PERCOLATION TESTING

SUBDIVISION Sand Hill Property LOT NO. 1 though 78

Sandhill Lots 5-8

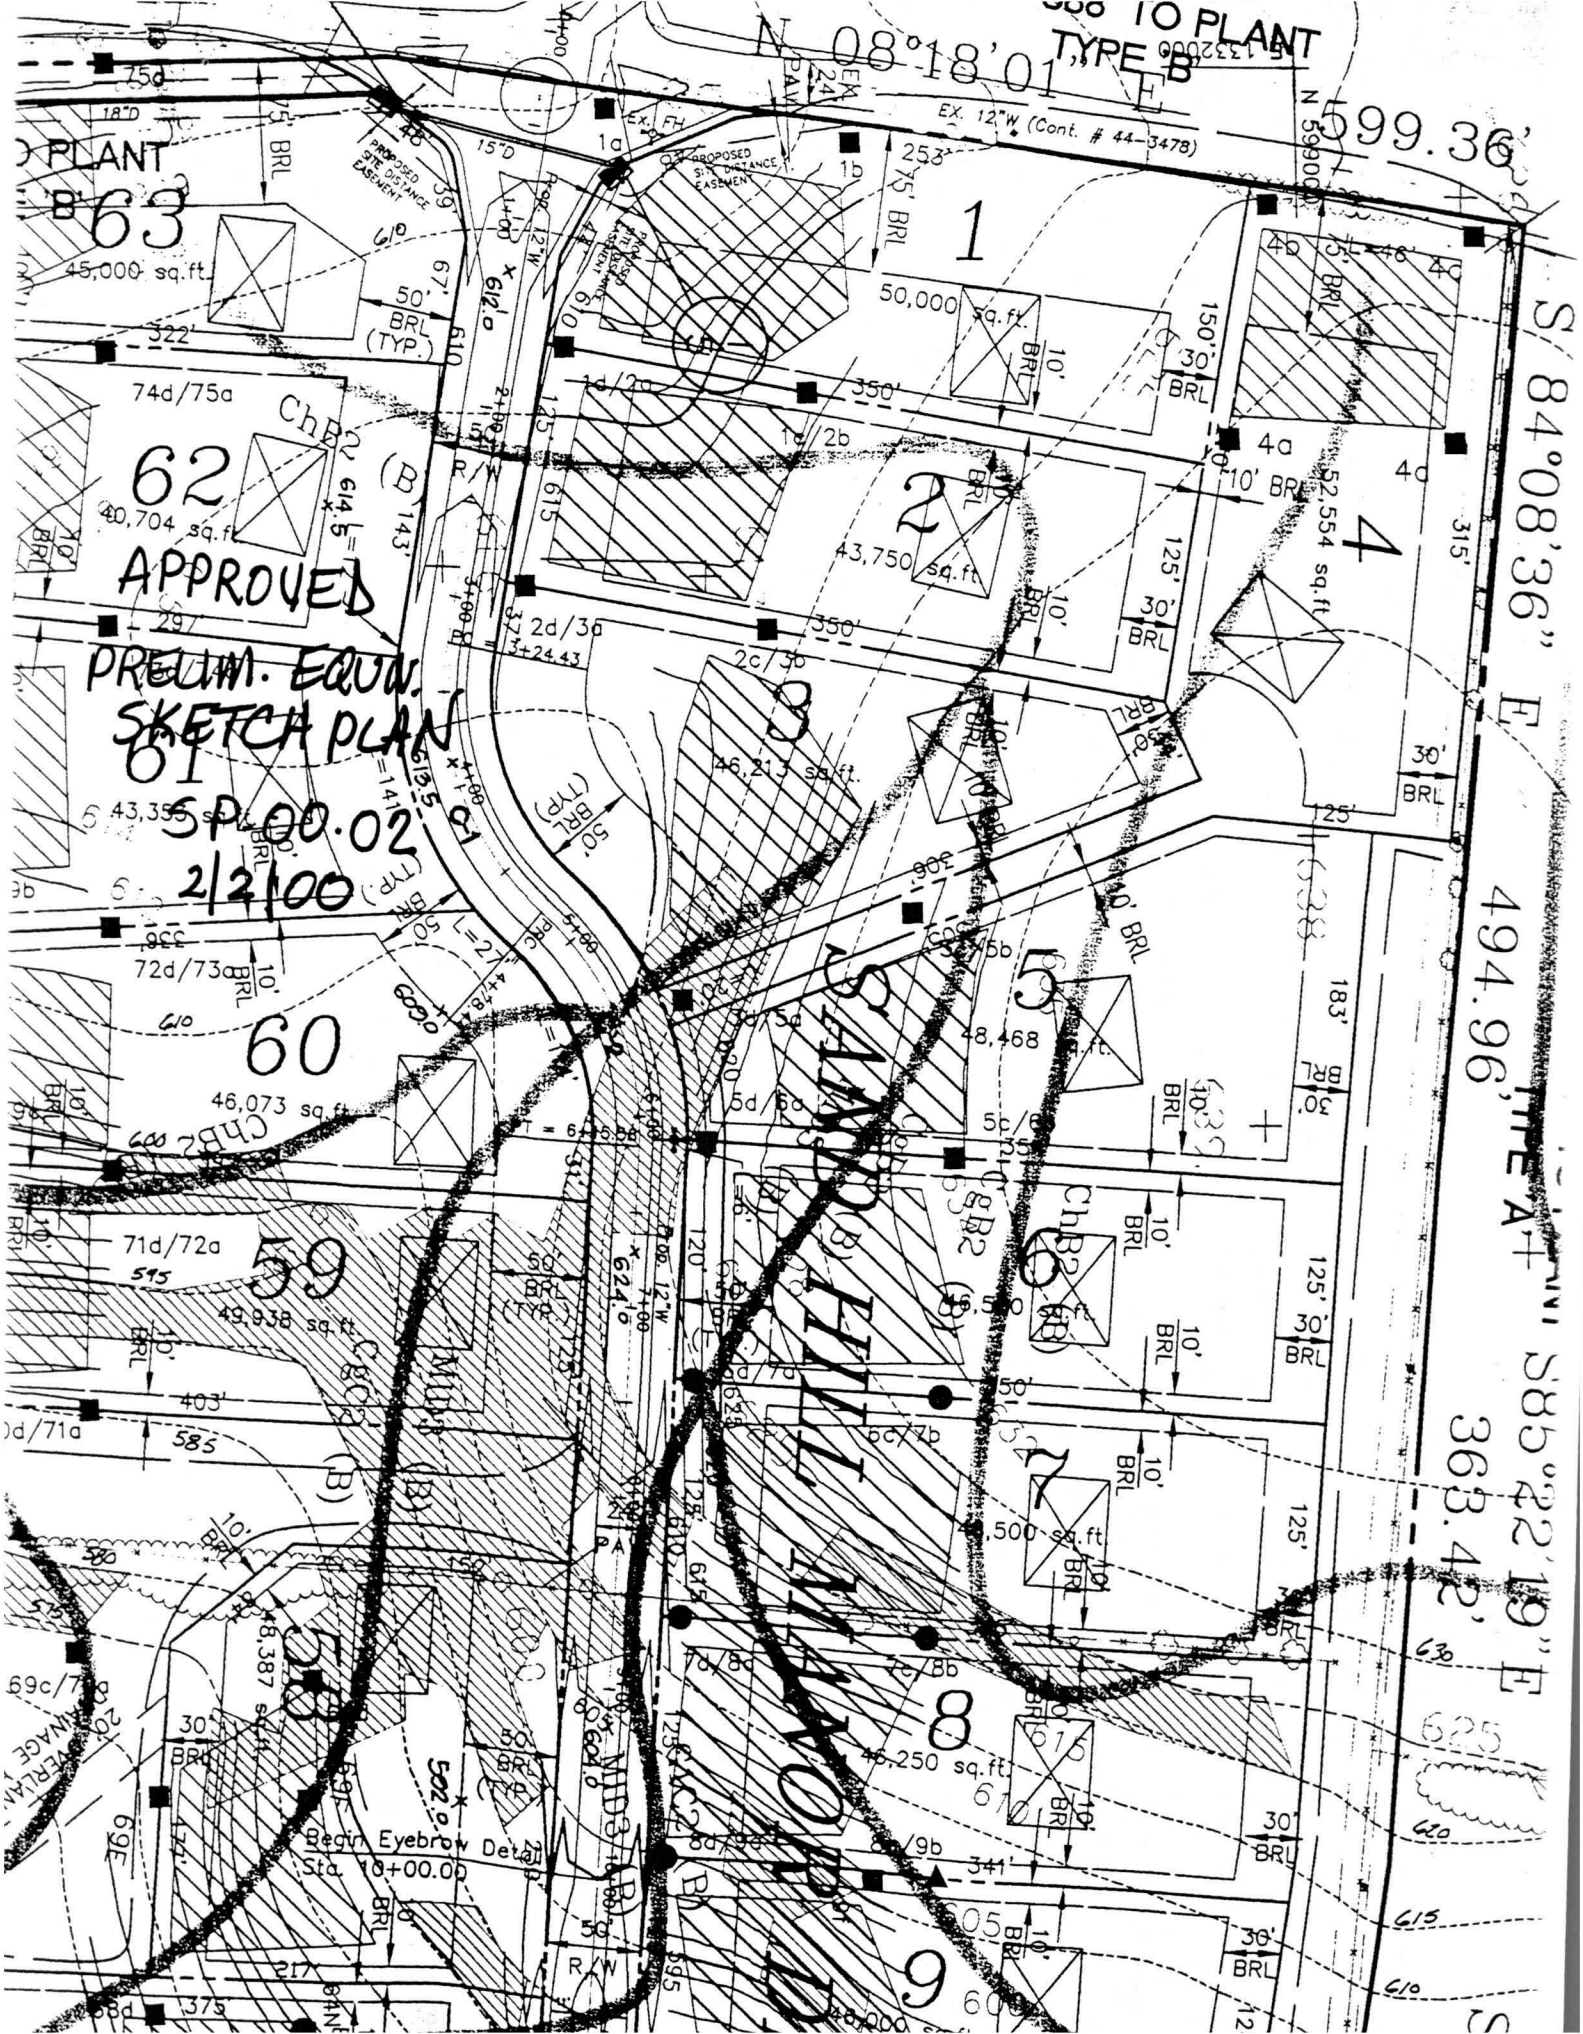
DATE	TEST NO.	DEPTH	PRE-WET		TEST - 1" DROP		TIME
			START	STOP	START	STOP	
4-13-99	8d/9a	4.5 V12.0	2:00	2:01	2:01	2:02	2min
	8c/9b	Amt of	rock & vertical pitch of				
		strata -	sewage would not be treated				F
	7c/8b	4.0 V12.0	2:36	2:37	2:37	2:39	2min
		8.0 V12.0	2:35	2:37	2:37	2:39	2min
	7d/8a	3.5 V12.0	2:40	2:42	2:42	2:42	2min
	6d/7a	3.0 V12.0	3:50	2:54	2:54	3:00	6min
	6c/7b	Visual	to IOD - see profile				OK

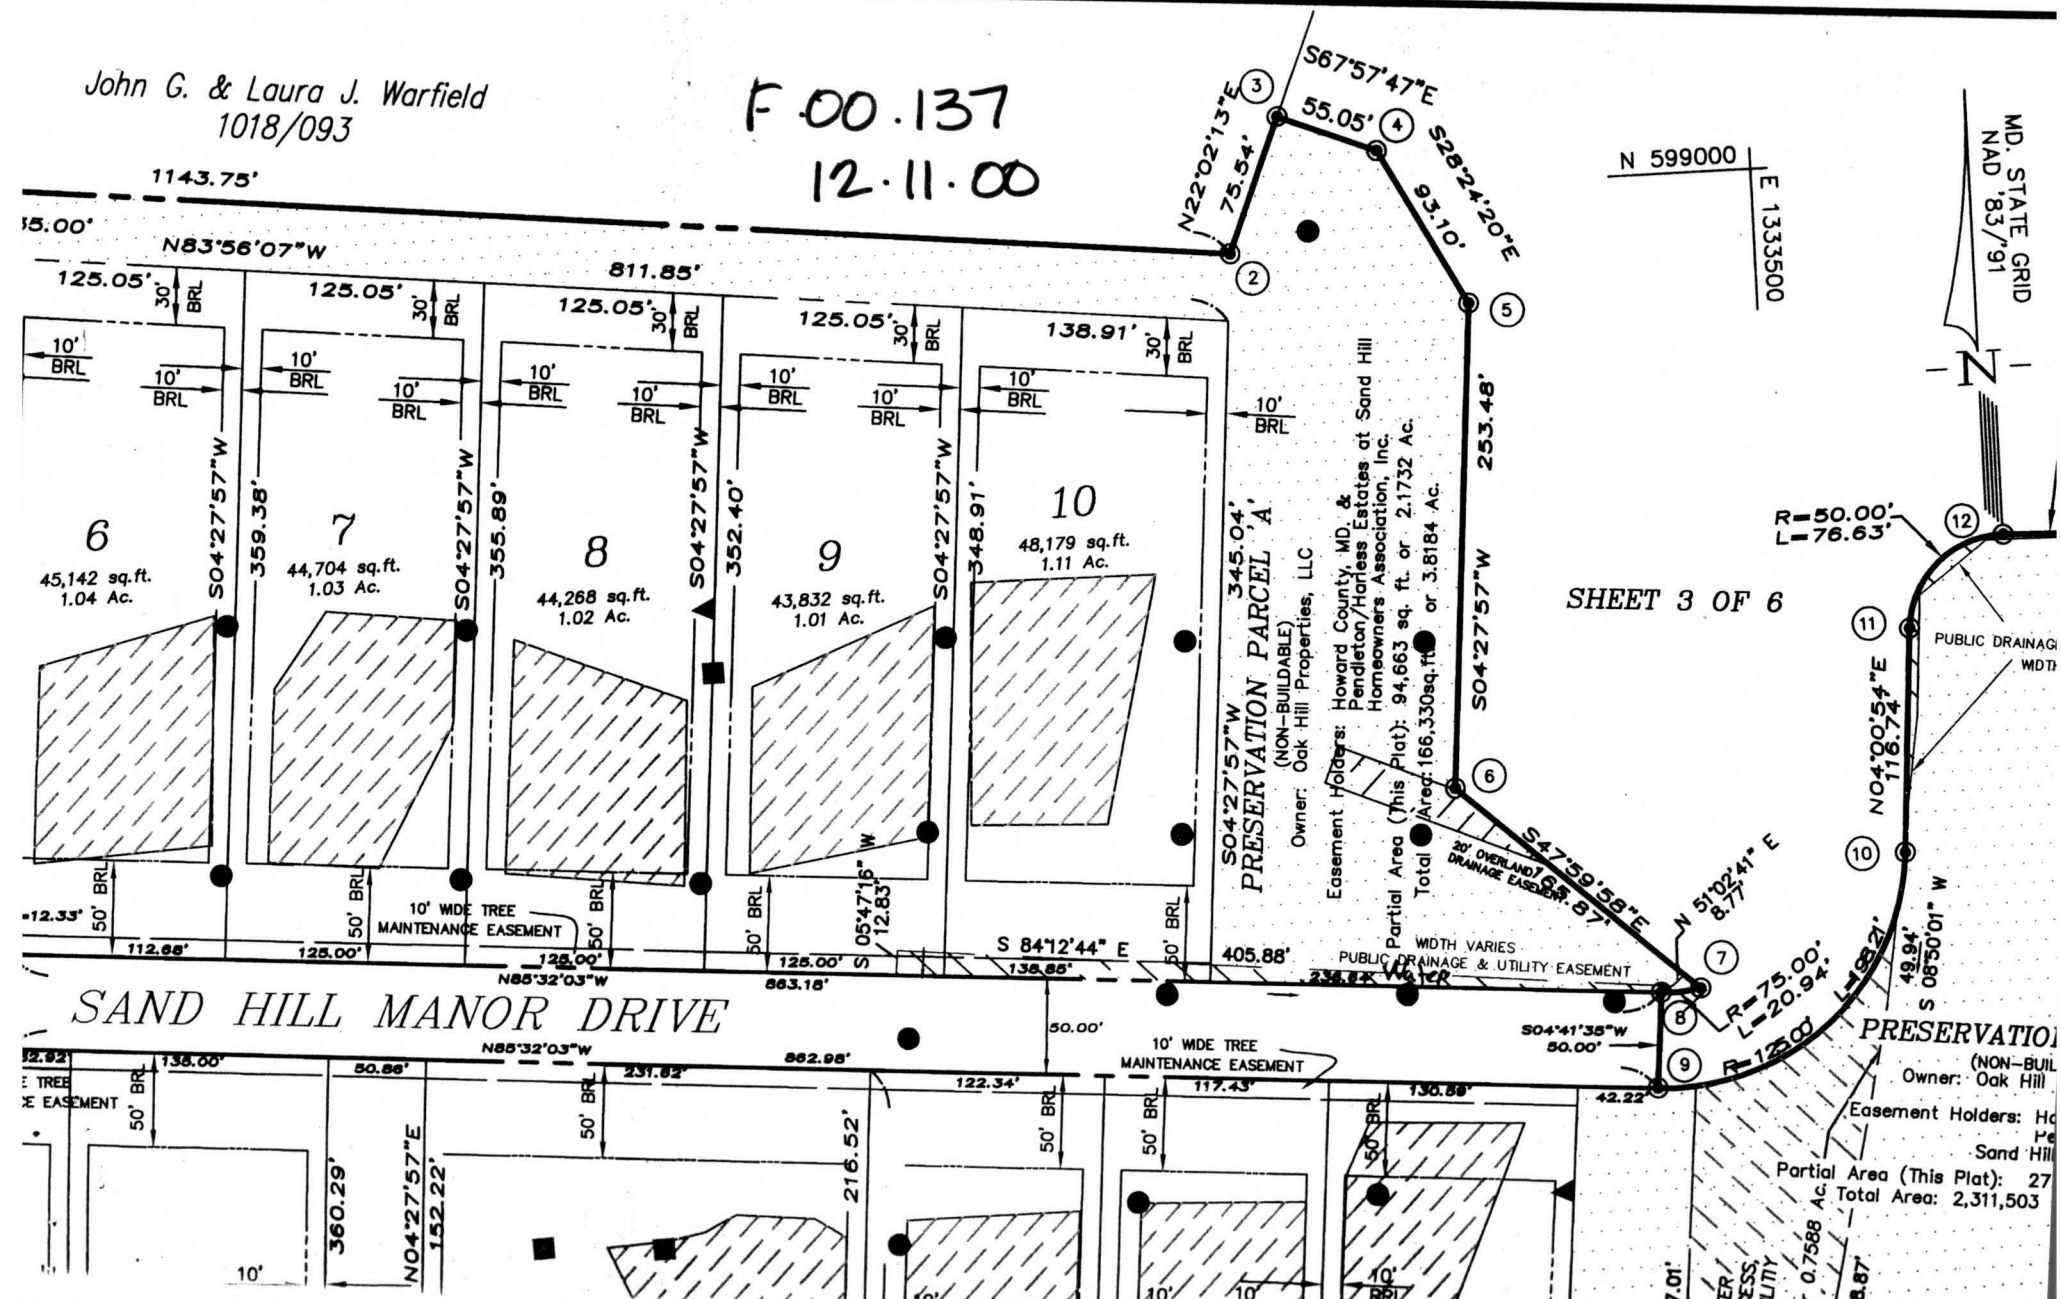
Lot ~~7~~ 7 & 8 are OK as proposed

Lot 6 would be OK if SDA is adjusted as shown
& 10,000 ft remains.

Lot 5 continues to be a problem - The shaded
area is the only usable portion of the SDA
once you account for 25' off 25% slopes and
a minimum of 50' trench length. And - the closest
perc hole on the left side of the lot is 50' from
the edge of the septic area. Again - I would
suggest a re-perc - I can do it almost any
afternoon
